**From:****Sent:** 12 May 2021 15:11**To:** Jill Bastow**Subject:** FW: Maid Marions, Robin Hoods Bay - NYM/2020/0885/FL and NYM/2021/0887/LB

General Notes		
No.	Revision/Issue	Date
Client I Ford & R Cuthbertson		
Name and Address Alterations Maryondale Cottage Albion Street Robin Hoods Bay		
Project Proposed First Floor one bed Maisonette Designated unit No 1 Second & Third Floor two bed Apartment Designated unit No2 Replacement of existing flue		
Date 08/10/20	Drawing No IB2020	
Scale 1:100	Sheet 2 of 3

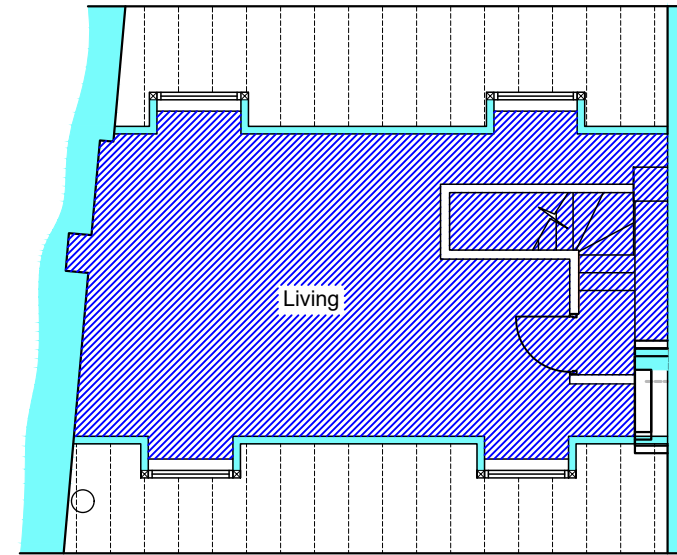
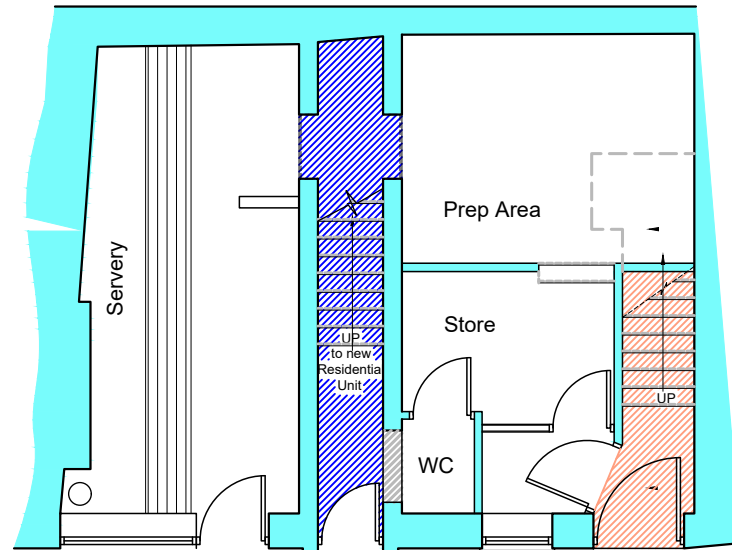
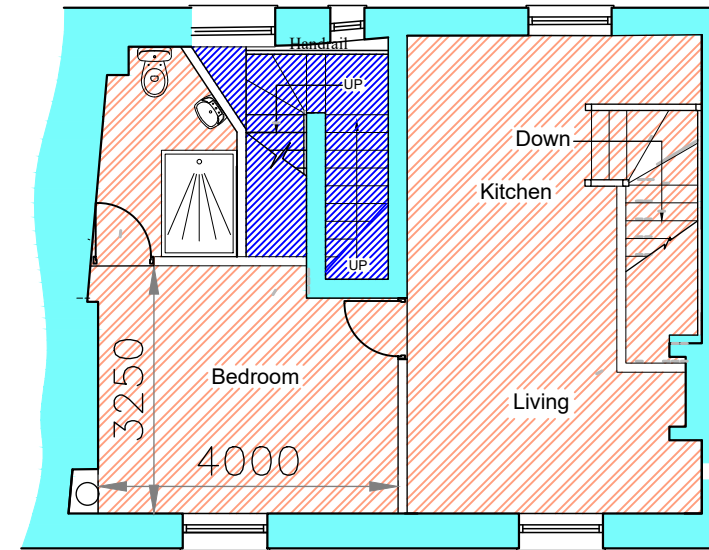
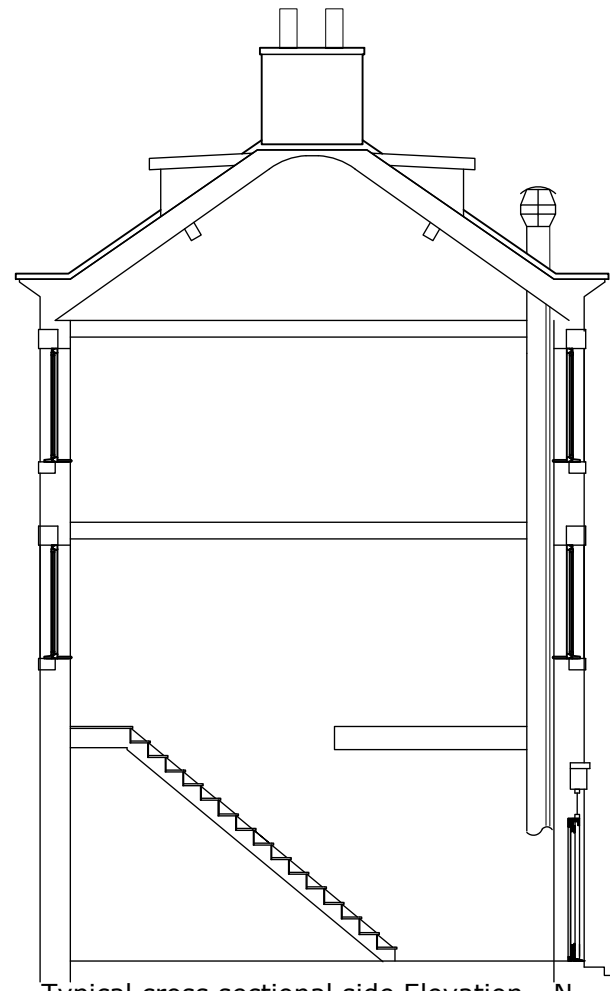
We are attaching a copy of a revised floor layout with Units 1 and 2 clearly labelled and colour coded to show floor layout including the means of access.

The internal layout suggested by the Building Conservation Officer has been studied by ourselves and it has become clear that Officers are not completely familiar with the layout and the floor plan/layout and regrettably this appears to have been misinterpreted. Please find attached clarification on the internal floor layout as follows:

- The building is not split with a left and a right over all floors and is not what we are proposing to achieve – we wish to retain the floor layout as per the existing/proposed plans.
- Building Regulations are unlikely to permit the floor layout being suggested by the Building Conservation Officer.
- The property benefits from 2 no. staircases and does not require a further staircase to get from the second to the third floor as indicated on the suggested plan.
- The door alignment for both sets of stairs confirms the stairs are in fact in the correct position as shown on the existing plan (the video confirms this).
- Plans prepared by a previous architect confirm the same layout as shown on the existing plans and are the same as those submitted as part of this application.

- To put a solid wall over the living area without a door would not make sense when the first floor space is interconnected across the whole of the floor. The first floor essentially makes up all of Unit 1.

- The proposed plan shows a stoothing wall with a door – your annotation shows a solid wall without a door to access what you wish to be a bedroom.
- Should you insist on the first floor bathroom being moved then from our position the pipework will have to move to skirt along the inside wall at the back of the building, at skirting level protruding 250mm into the landing space. Due to uneven and protruding walls (in places) it will result in a loss of habitable floor area. There will not be sufficient space at the top of the stairs, in the stairwell, to create a regulated landing space due to the need to box in pipework and also look unsightly.

- Ideally the bathrooms will remain in the same place over the first and second floors and for the necessary pipework to stay in place.

- The central door on the front elevation is aligned with the staircase which provides access to Unit 2 only. It is independent to Unit 1.
- The right hand side door on the front elevation provides access to Unit 1 only and is aligned to the existing staircase to the first floor only (Unit 1 only). The staircase is existing as is the central one.
- To put the staircase where it is being suggested would need the walls moving closer to any new stair built and an access door plus a landing at the base which would further lessen the usable floor area. It would not make practical sense or sensitive works to the listed building.

Date	08/10/20	Drawing No	1B2020
Scale	1:100	Sheet	3 of 3

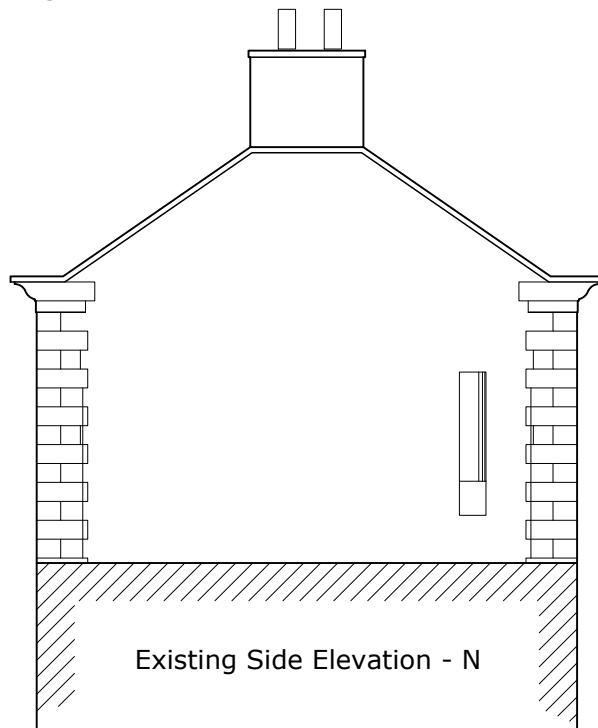
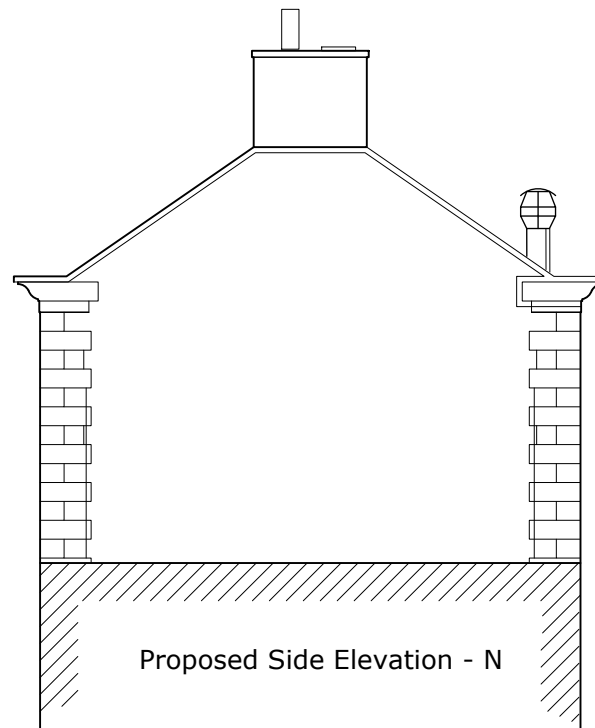
- It is concluded that there is simply no option to put the flue through the top part of the chimney. The attached photograph with brick highlighted yellow shows the very narrow width of the flue inside the chimney.

- It is at third floor/upper floor level and within the part of the projecting element of the stack where the flue narrows to an 8 inch diameter.
- The proposed flue is 360mm diameter which is almost double the width needed to take the ventilation flue.

- Trying to make the flue fit through the chimney is simply not possible nor is it possible to take off the internal face of the chimney stack to make way for the flue as it could render the whole of the stack weaker than it already is and therefore unsound. We wish to put this forward as being material to the case and it is because of this reason therefore it is not physically possible to have the flue through the existing stack.

- The only option we are left with, given the neighbour will not allow the flue to project over his building on the side gable, is to proceed with the 2nd proposal to bring the chimney through the front roofscape with a small flue. Drawing amended and attached as requested.

STONE COVERED INSPECTION  
 ACCESS POINTS ATTACHED  
 AS DESIGNED BY THE FLUE  
 SUPPLIERS AND QUANTITY  
 TO BE AGREED AT TIME OF  
 FITTING

VISIBLE FLUE TO BE COATED  
 IN MATT BLACK FINISH

B	Flue repositioned and access for maintenance by removable stone covers	08/02/21
	Unit designated No's 1 & 2
